Source: SK Telecom

Title: CR for TAB structure and timing relation for USTS in 25.211

CR 016

Subject: TAB structure and timing relation for USTS

Figure 10: Frame structure for downlink DPCH

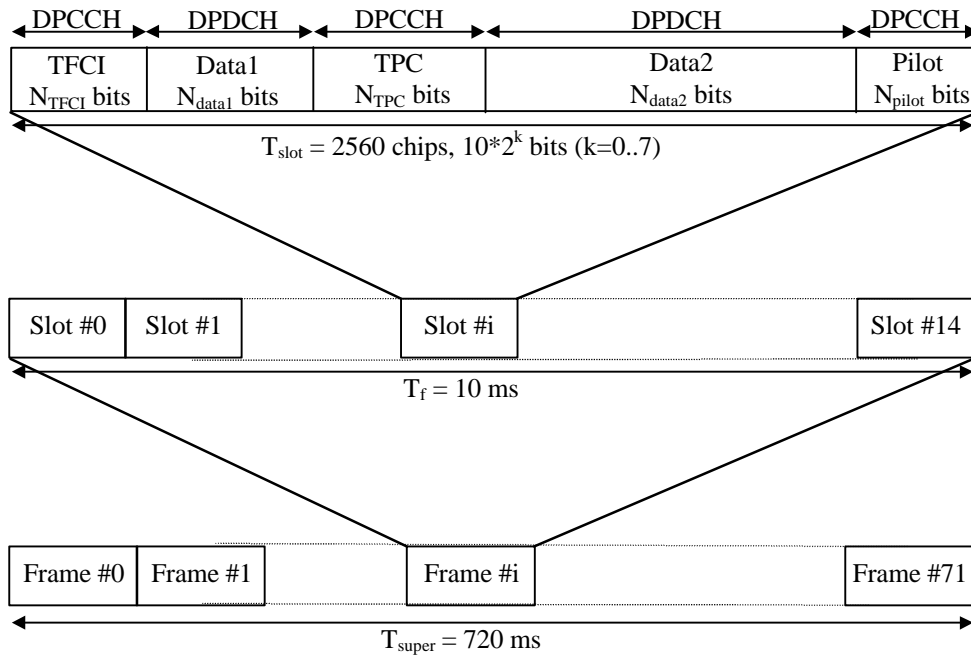
Within one downlink DPCH, dedicated data generated at Layer 2 and above, i.e. the dedicated transport channel (DCH), is transmitted in time-multiplex with control information generated at Layer 1 (known pilot bits, TPC commands, and an optional TFCI). The downlink DPCH can thus be seen as a time multiplex of a downlink DPDCH and a downlink DPCCH, compare Section 5.2.1. It is the UTRAN that determines if a TFCI should be transmitted, hence making it mandatory for all UEs to support the use of TFCI in the downlink. [In case of USTS, the TPC bits in slot #14 in frames with CFN mod 2 = 0 are replaced by Time Alignment Bits \(TABs\) as described in section 9.3 of TS 25.214.](#)

Figure 10 shows the frame structure of the downlink DPCH. Each frame of length 10 ms is split into 15 slots, each of length $T_{slot} = 2560$ chips, corresponding to one power-control period. A super frame corresponds to 72 consecutive frames, i.e. the super-frame length is 720 ms.
